That the Cambridge City Council hereby grants permission to Massachusetts Institute of Technology to undertake street work for the extension of M. I. T.'s chilled water system as per drawings CHWD-3 through 6 on file with City Engineer and City Clerk.

Subject: Chilled Water Distribution System
East Campus Chilled Water Plant

Chilled Water Distribution System
East Campus Chilled Water Plant

In response to your May-13 letter concerning the distribution piping arrangement indicated on drawings CHWD 3 thru 6, the P&D offers the following comments and recommendations:

TYPICAL TRENCH DETAIL

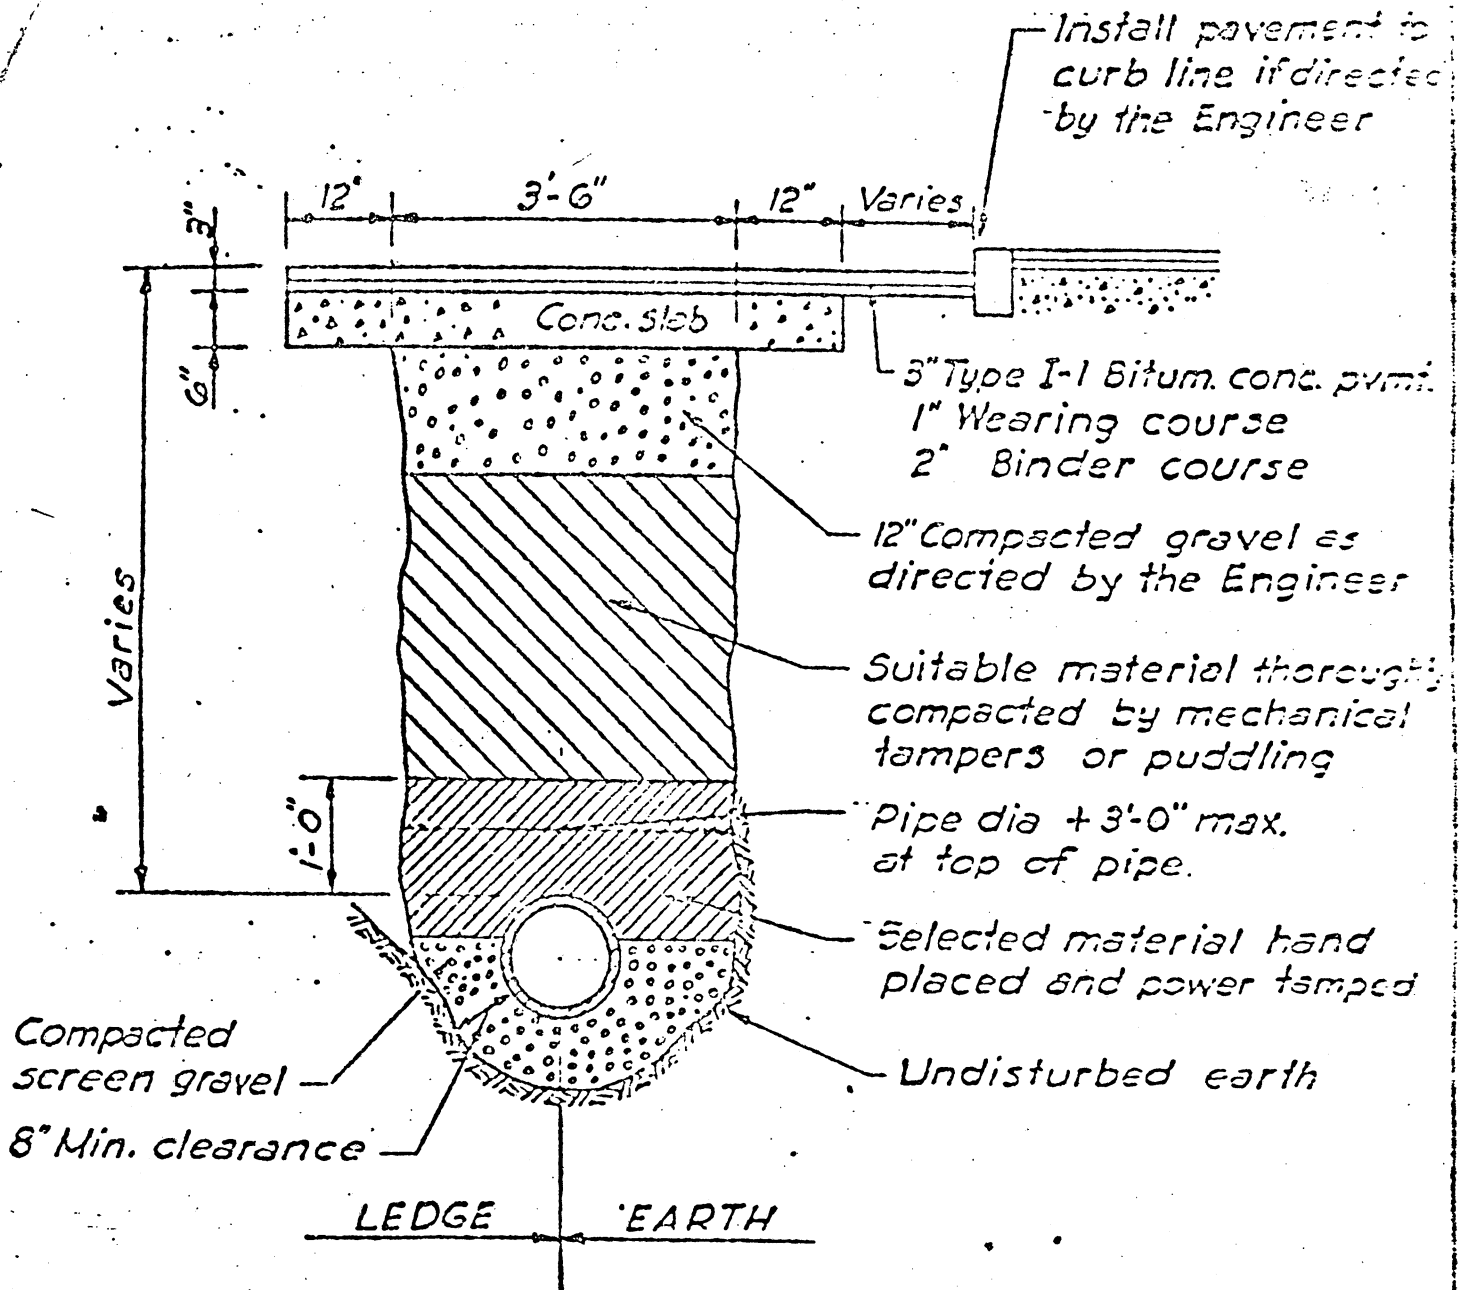
2. The roadway construction standards of the City for all pipe line installation require a 6-inch cement concrete slab over the trench beneath the bituminous concrete pavement as indicated on the attached detail.
